PG&E Letter DCL-03-121

Docket No. 50-323, OL-DPR-82  
Diablo Canyon Unit 2  
PG&E Response to NRC Questions on 2R11 Steam Generator Tube Inspections

**PG&E Response to NRC Questions on Unit 2 Eleventh Refueling Outage  
Steam Generator Tube Inspection 90-Day Report**

Figure 11-1

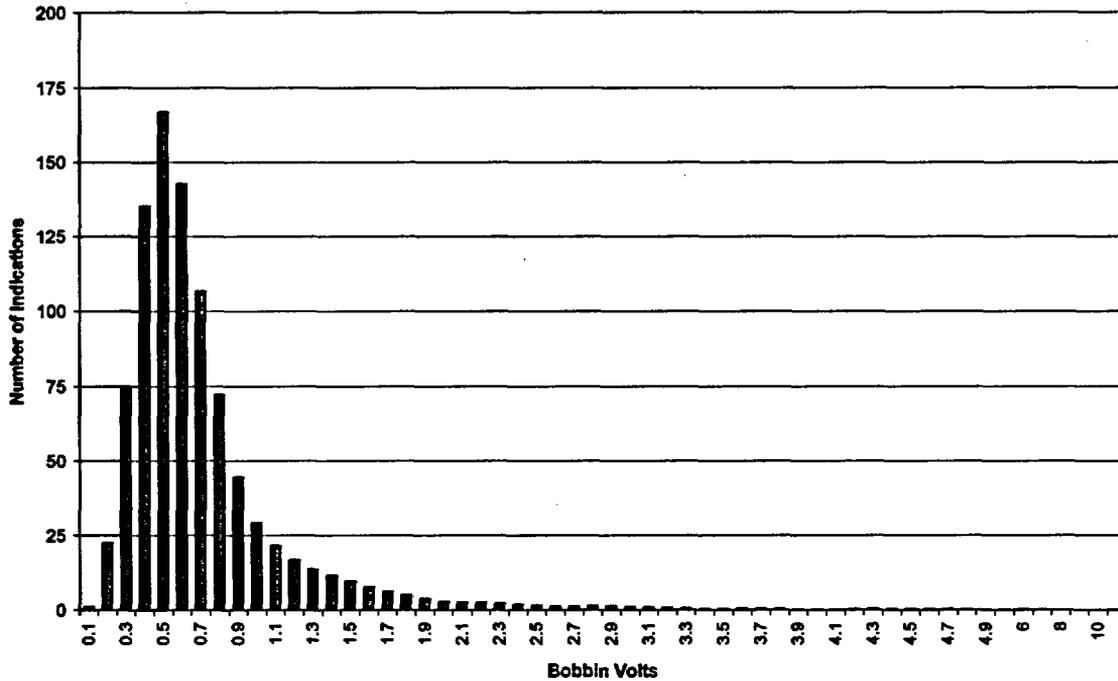
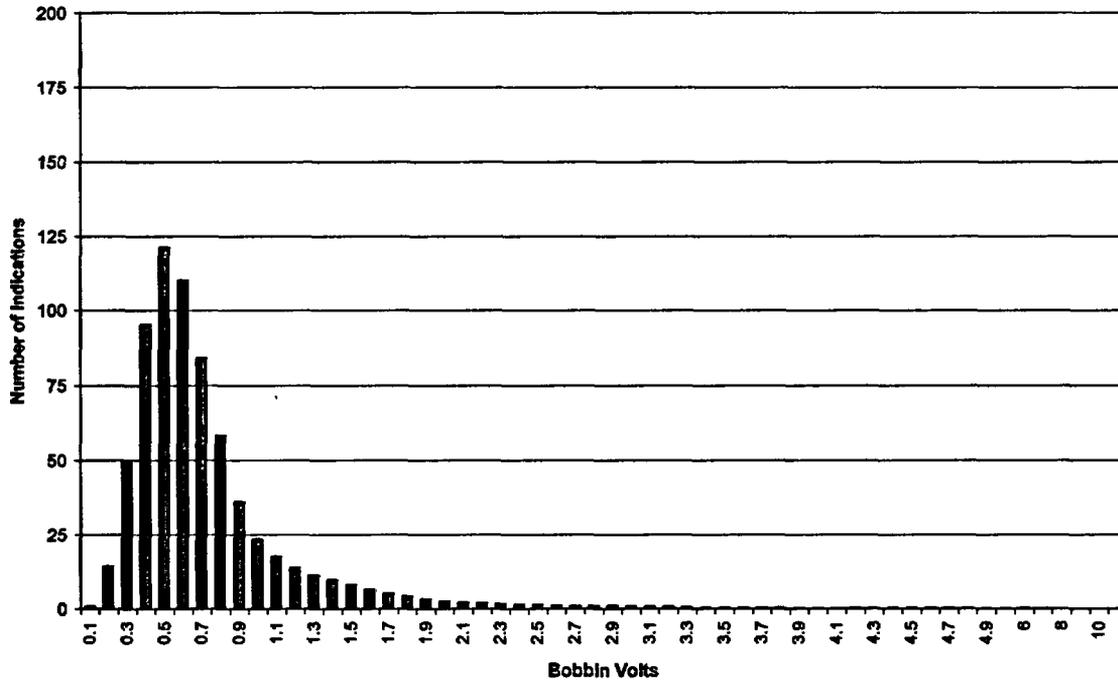
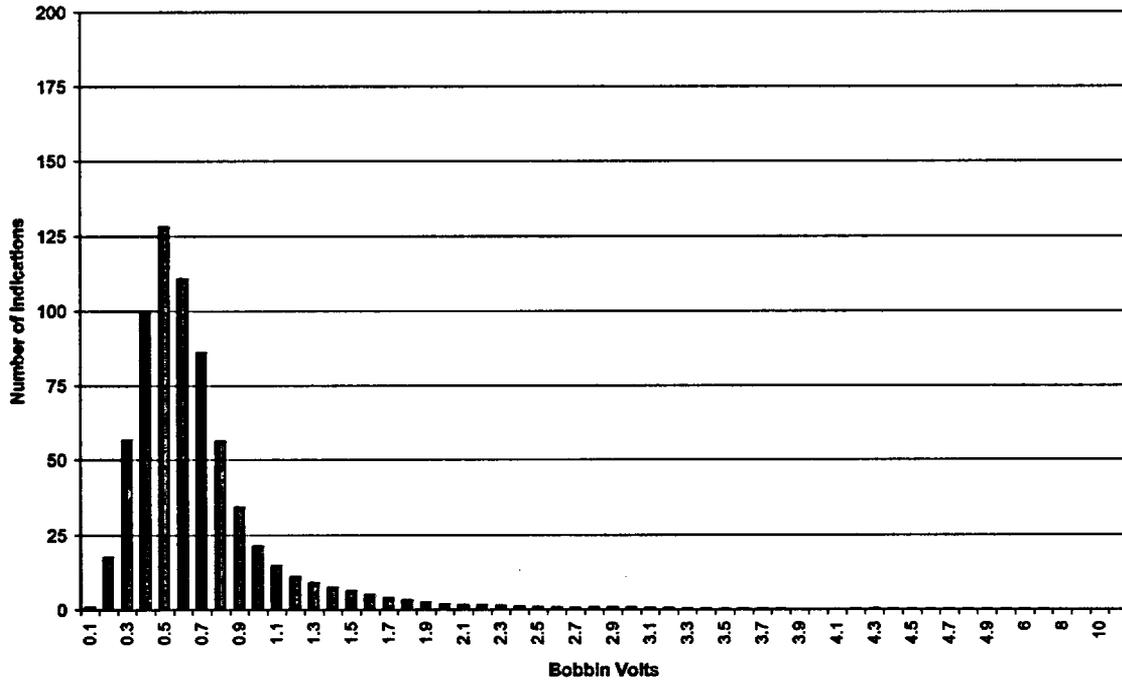
*"Provide the EOC-12 Projections and POB and leak rate results of record for the method that PG&E has determined to be the most appropriate for predicting EOC-12 conditions."*

Table 11-5 provides the EOC-12 projected distributions that will be assessed against the as-found conditions at EOC-12. Figures 11-1 through 11-4 provide the EOC-12 distributions graphically.
